## Preliminary Adequacy Review, TR-17, Lyons Quarry M1977-208

RE: Preliminary Adequacy Review; Technical Revision #17 (TR-17);  
Lyons Quarry; DRMS File No. M-1977-208;

## Lyons Quarry C-Pit Status

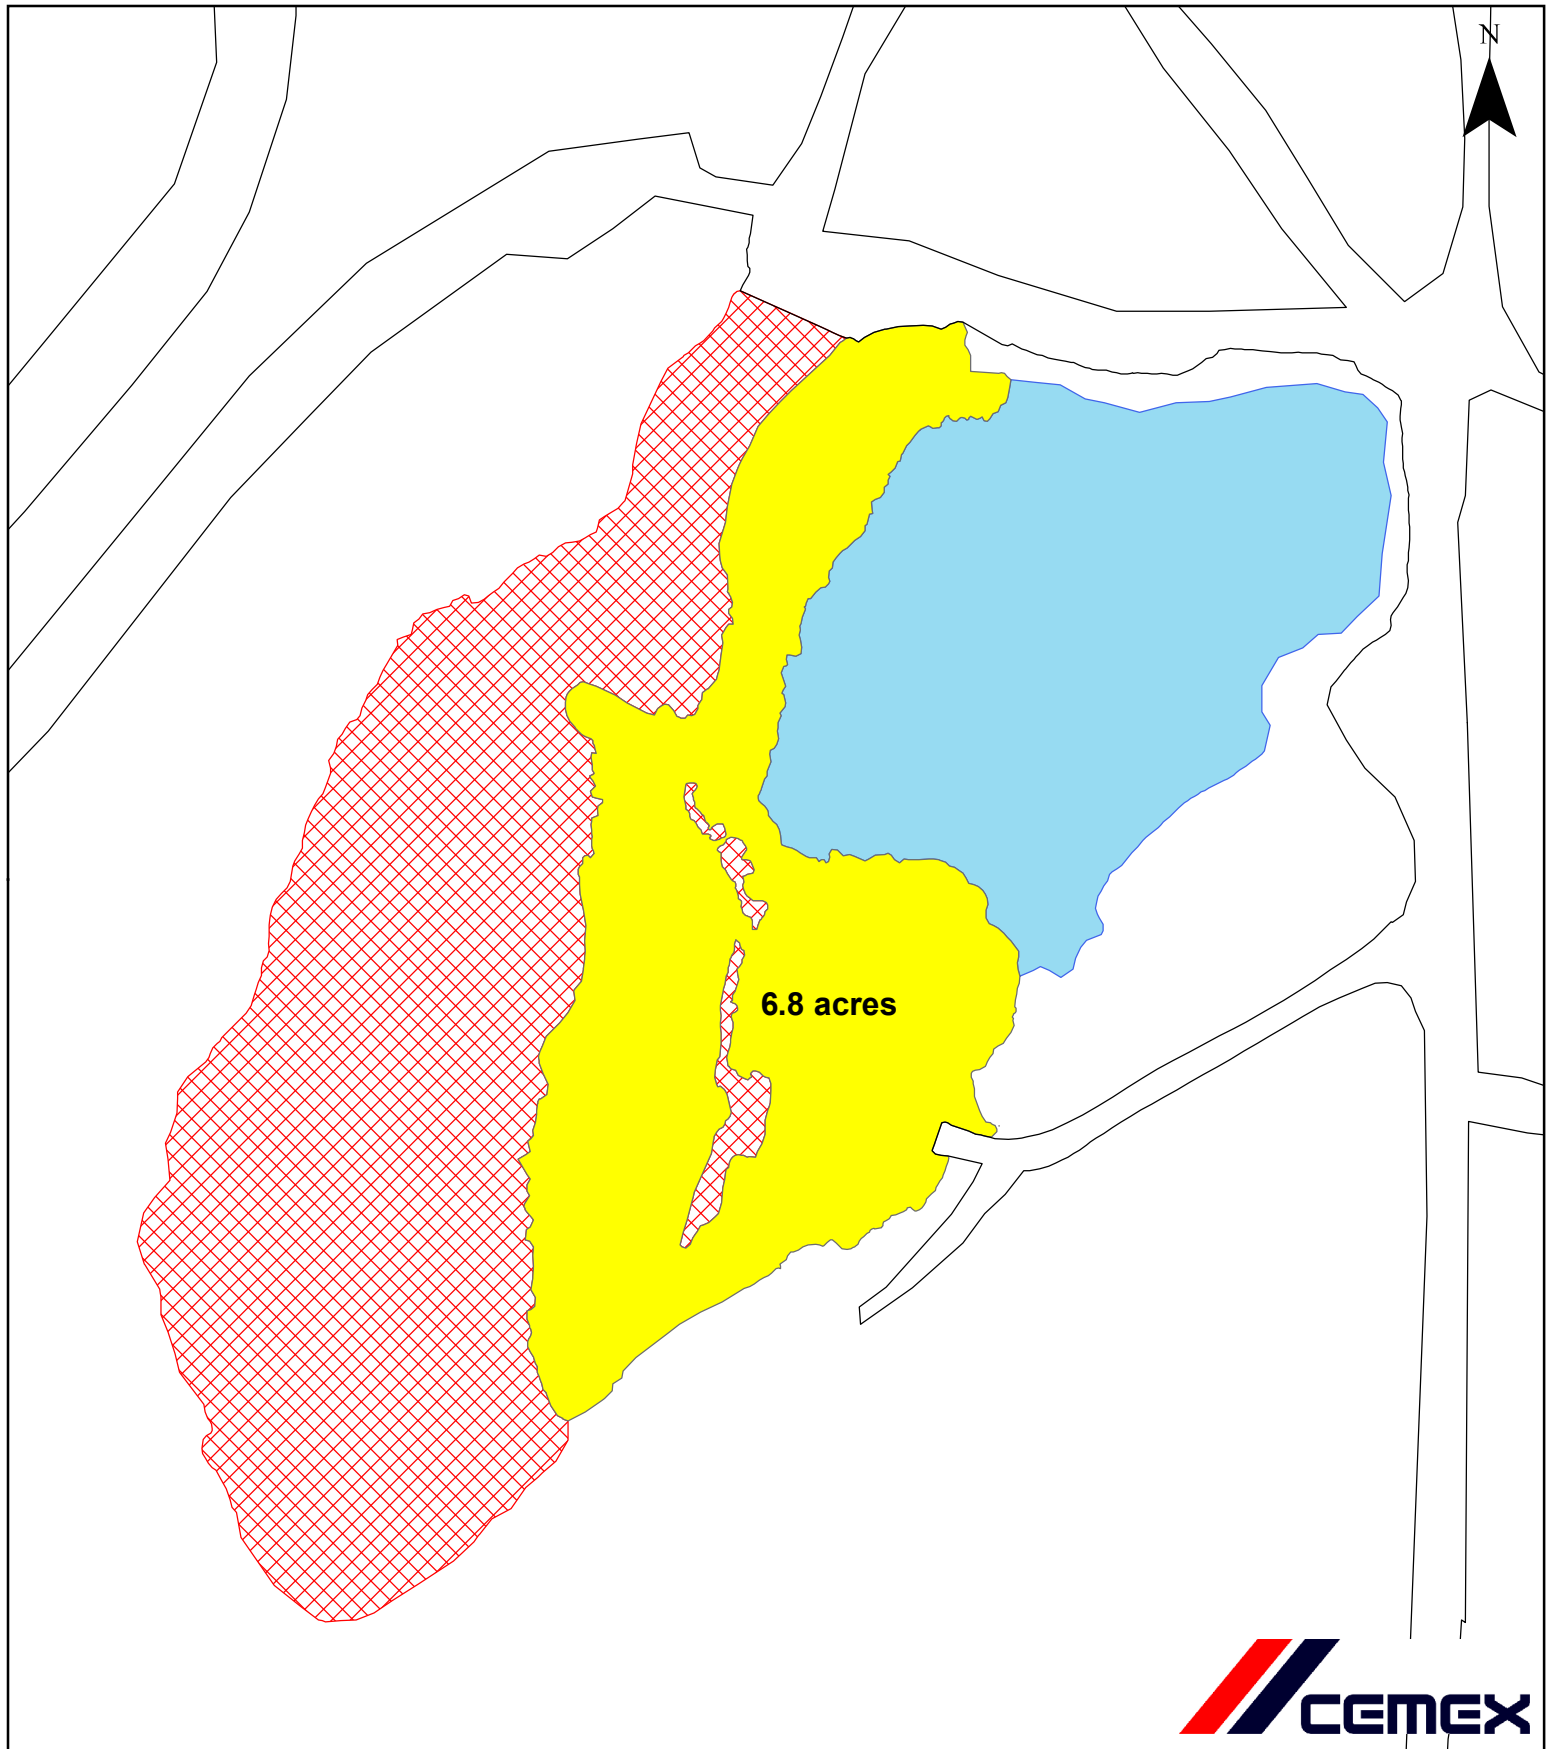
1. The aerial map provided does not account for all the exposed CKD sideslopes, as requested in the problem citation, especially along the NW edge of the pit. Please provide an updated map that accounts for exposed sideslopes and clearly indicate the total acreage of exposed CKD.

*See attached Map File "C-Pit Status-Acrews\_o8222022.pdf" which depicts total surface area including sideslopes. This total exposed CKD area is 6.8 acres.*
